Access Compliance Report

Public Rights-of-Way

Intersection ID: 54413	Main Street: ARDREY_KELL_RD	Cross Street: LISMORE_LN	Location: E
ADA ID: 4454A8CDDD46	Ramp Type: Directional1	Initial Pass/Fail: Pass	Overall Compliance: No
		Severity Score: 15

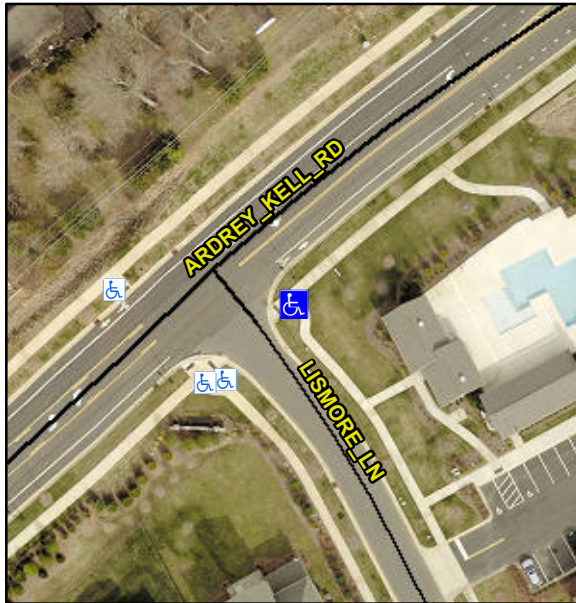
Possible Solutions:

Grind Gutter Lip.

Surveyor Notes:

ROAD TO BE RESURFACED

PROW/ADA:

R302.7.2
